URBAN DESIGN REVIEW WATERLOO ESTATE SOUTH

Hassell has been engaged by DPIE to undertake a 'broad and holistic' urban design review of the Waterloo Estate (South) Planning Proposal prepared by the City of Sydney.

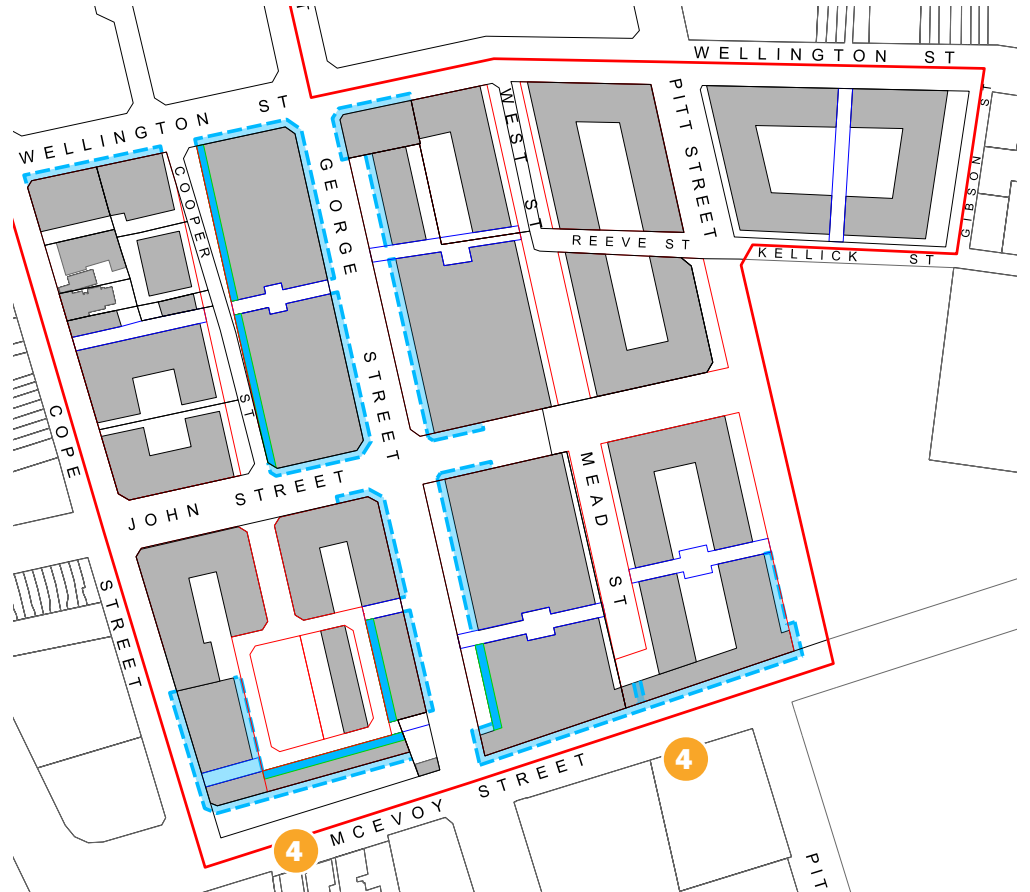
1. Extension of active frontage of the 2 lane ways to the east of George Street does not connect to the street beyond.
2. Active frontage east of McEvoy Street is very close to the busy road.
3. No active frontage to the built form adjacent to the small south east park.
4. Awnings are allocated below tower to levitate the effect of down draft wind.
5. Solar access to open spaces (streets, parks, courtyards etc) within in the precinct could be compromised by tall and long buildings, creating cold and dark conditions during winter.

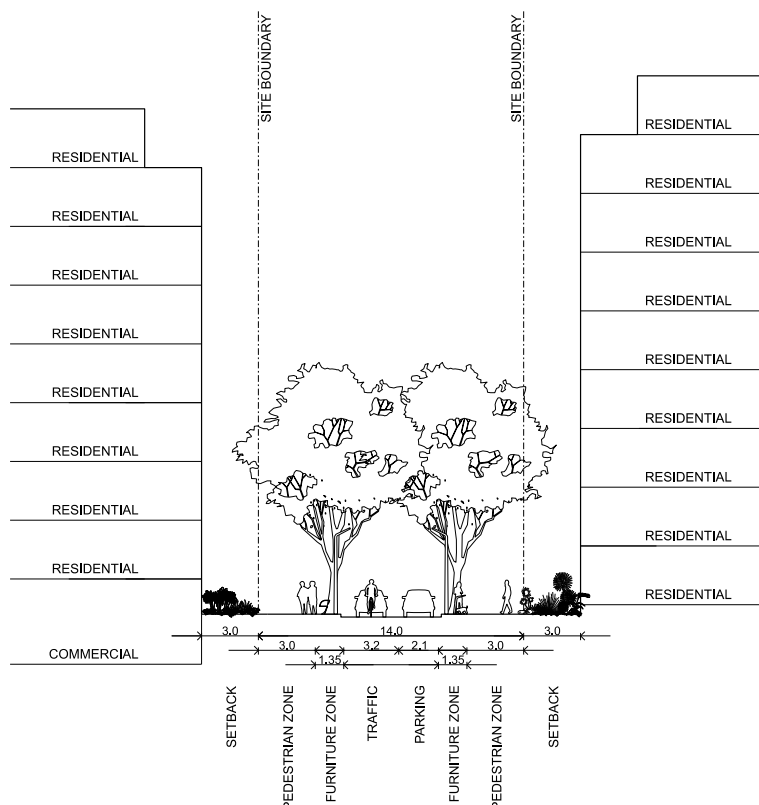
1. Setbacks should relate to use, thermal comfort, opportunities for existing tree retention etc.
2. Inconsistent application along Pitt Street
3. East and west blocks of McEvoy Street have inconsistent setbacks. No setback provision to the eastern block to allow tree retention.

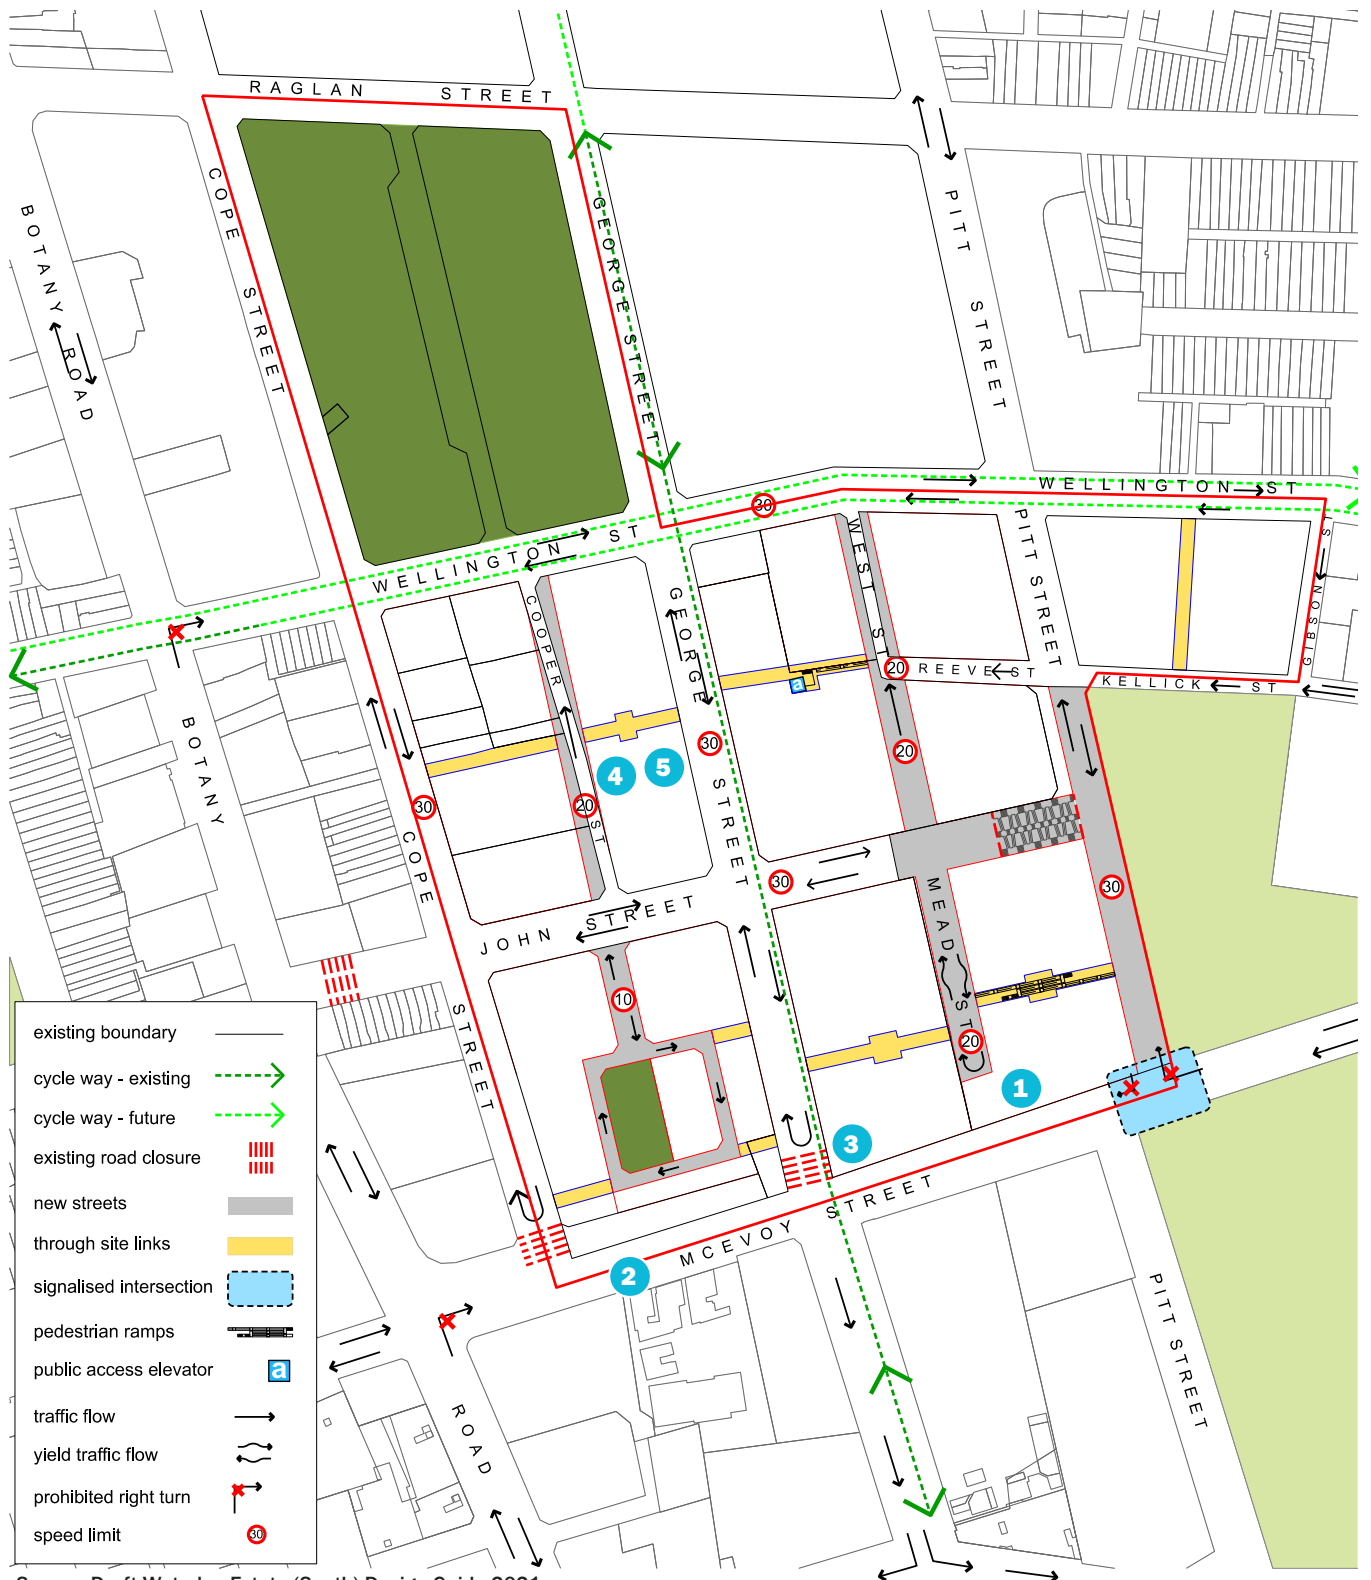
1. The proposed street blocks knit Waterloo South into its urban context and replace former streets that existed prior to its creation as a public housing precinct.

4. Vehicular connection blocked from George Street to McEvoy Street - CoS Planning Proposal notes that the blocked entry from McEvoy Street is to avoid 'rat runs' through Green Square precinct. Pedestrian and cycle permeability at this intersection is provided.

5. The location of mid block links provide additional permeability to long street blocks, and are appropriately located.
6. The character of the mid block connections requires careful design attention owing to the scale of adjacent buildings.

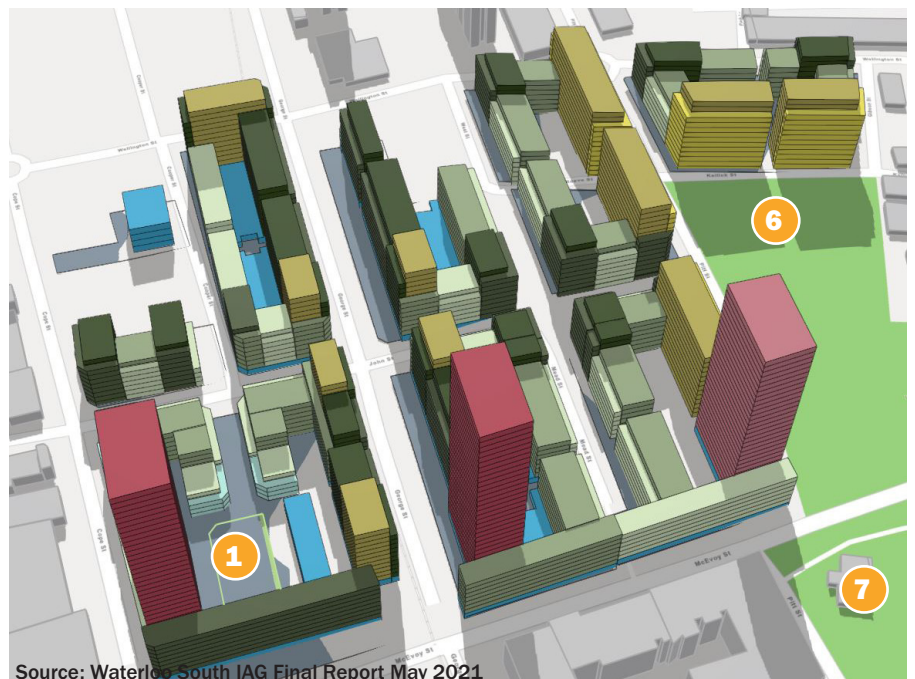
1. Location of smaller park to the south west is very contained. Solar access to the park is potentially impacted by the surrounding building mass.

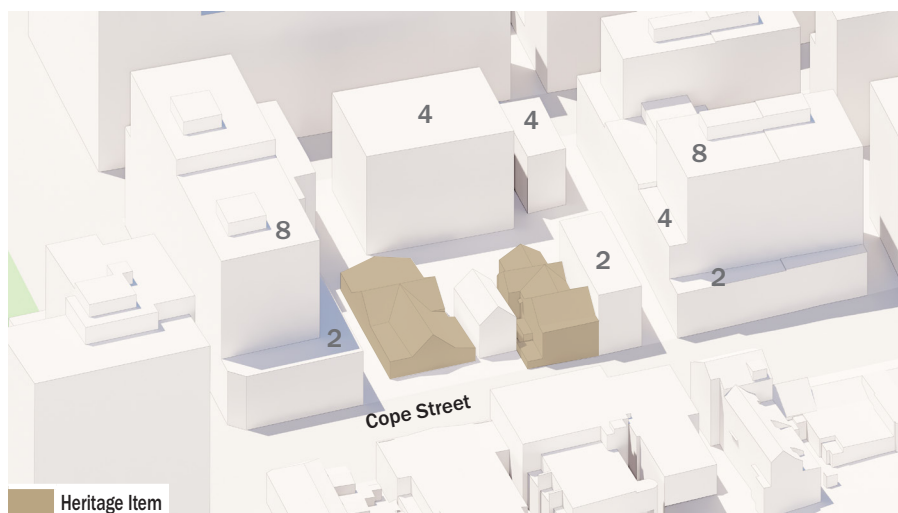
The proposal built form around the heritage terraces on the northern end of Cope Street are of small scale. Sets an appropriate height and transition to the taller buildings further away.

The proposed height to the north of the heritage items will create additional overshadowing between 9:00am and 3:00pm mid winter, resulting in the POS and potentially living room to receive less than 2 hour direct solar between 9:00am and 3:00pm mid winter.

4. Heritage Conservation Zone

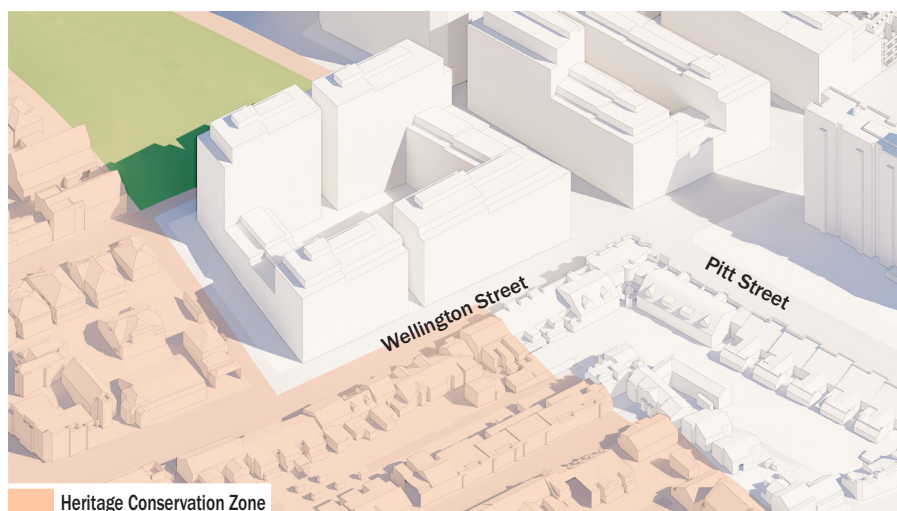
Transition and relationship to the heritage conservation zones should be carefully considered through the design of the building massing, bulk and scale. This is to be addressed in design guidelines.

Axonometric of Planning Proposal and surrounding built form - view towards McEvoy Street

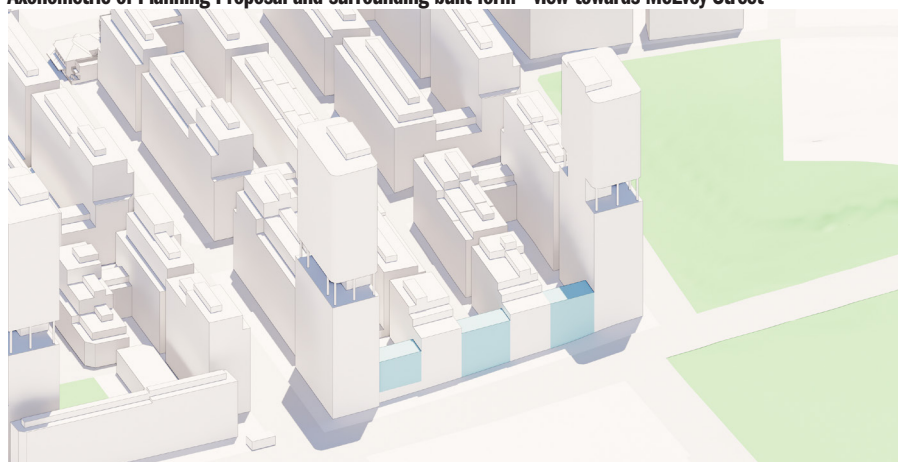
No setback requirement to the east block of McEvoy Street compared to the west. McEvoy Street is a busy street with high traffic and pollution. A large amount of trees are proposed to be removed with the built form from Planning Proposal. It is recommended to retain additional trees along McEvoy Street to provide better pedestrian as well as building amenity. Utilising existing trees as buffer between the street and the future apartments.

By setting back the east block along McEvoy Street, it allows additional trees to be retained. 2 high value trees will need to be removed so on balance, 5 moderate value trees and 2 high value trees will be retained through this recommended change in massing.

By allowing connection from Mead Street to McEvoy Street, an additional 2 high value trees can be retained. The connection can be non vehicular to provide pedestrian and cycle access only.

Proposed section through George Street west block with ADG compliant building separation

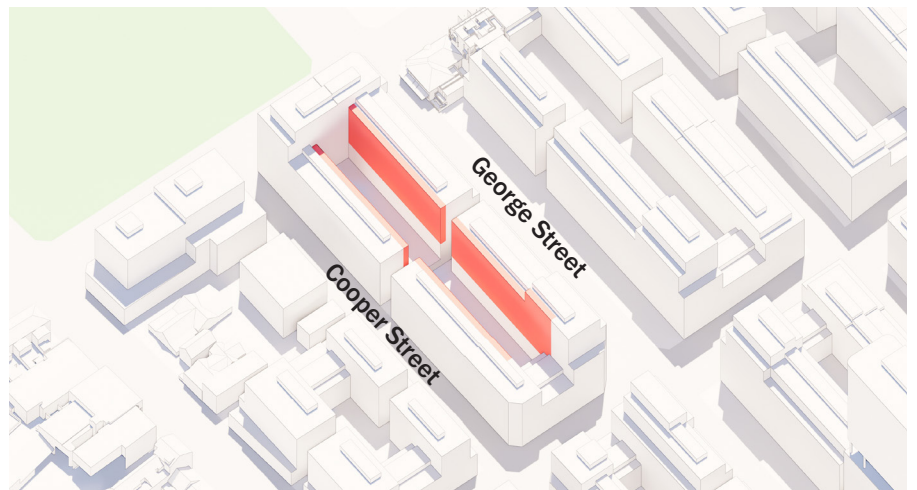
Cooper Street has been realigned in the Planning Proposal to create more consistent street blocks. George Street has been widened as it is proposed as the main commercial/retail street within the precinct. The location and alignment of these two streets resulted in the maximum block width.

For the built form to comply with ADG requirements within the envelope, design attention to apartment arrangement and window placement is required. The recommended approach is to provide for compliance at a detailed design stage.

Winter Solstice

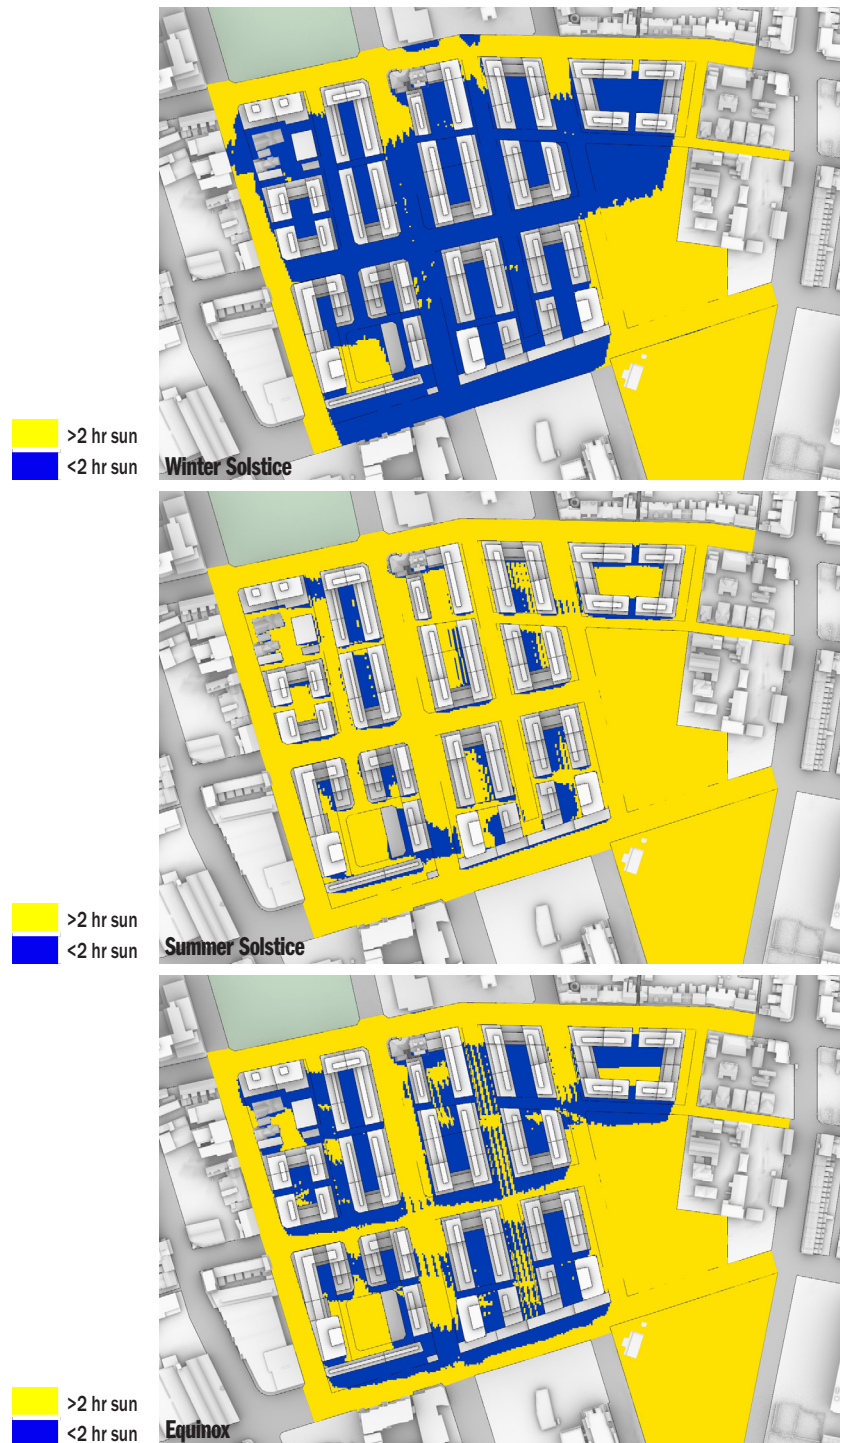
1. All shared courtyard spaces within the perimeter building blocks do not receive a minimum of 2 hour solar access between 9am-3pm mid winter
2. The majority of George Street, Mead Street, West Street, John Street and Cooper Street have minimal access to sunlight between 9am-3pm mid winter.
3. The south west park has good solar access mid winter.

Winter Solstice

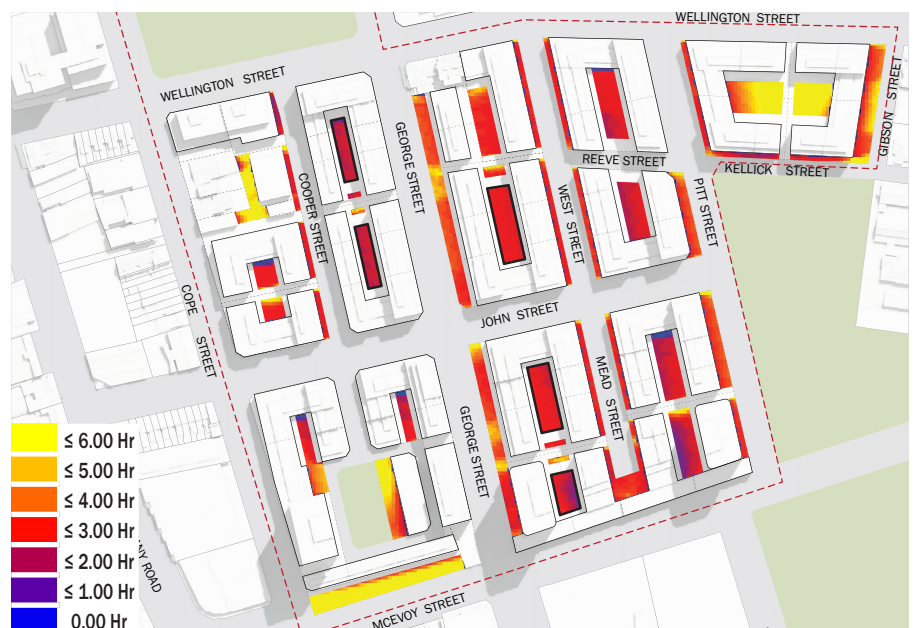
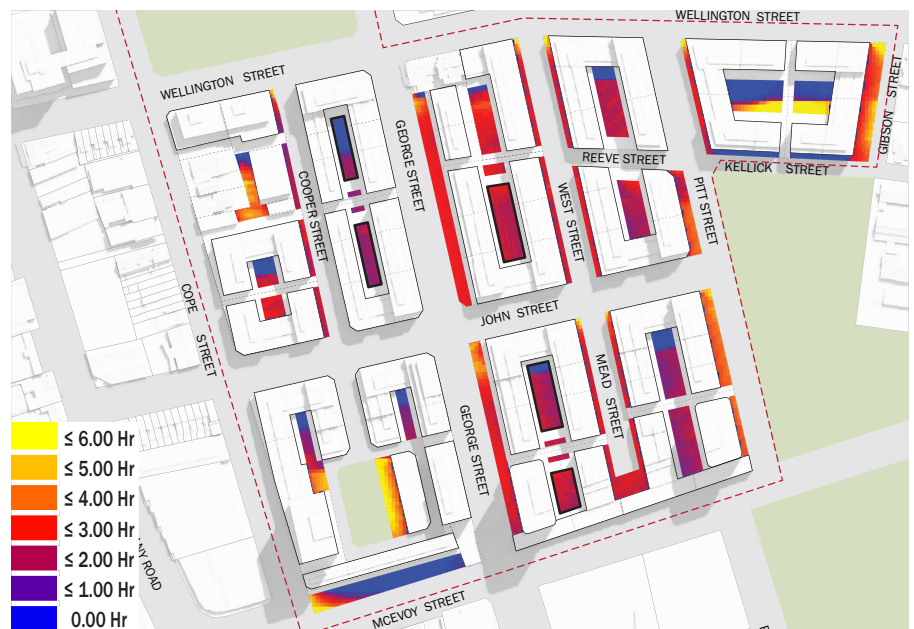
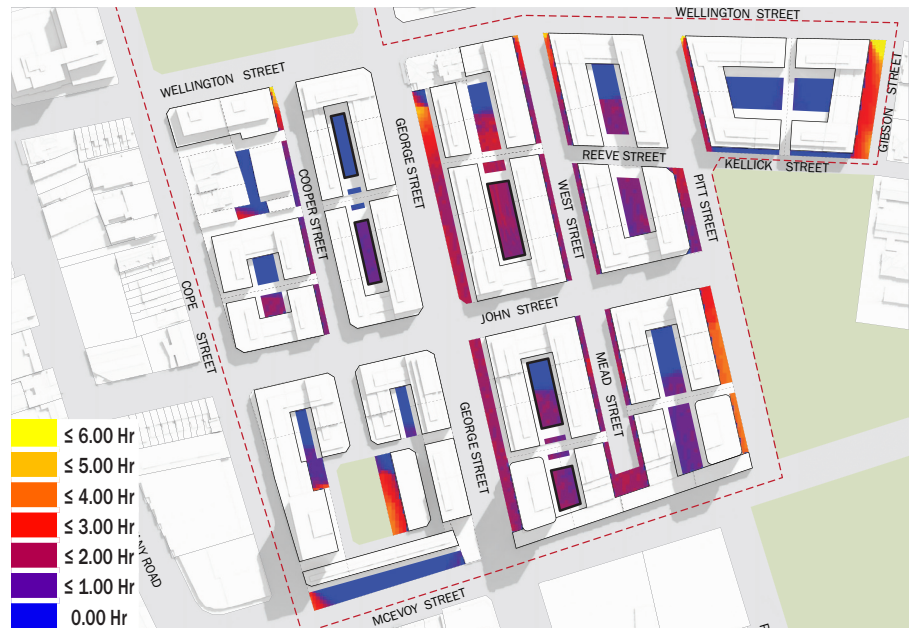
1. All shared courtyard spaces with deep soil zones within the perimeter building blocks receives less than 2 hour solar access, some less than 1 hour.
2. The majority of George Street, Mead Street, West Street and Cooper Street have minimal access to sunlight
3. Pitt Street north and Kellick Street also have minimal access to sunlight.
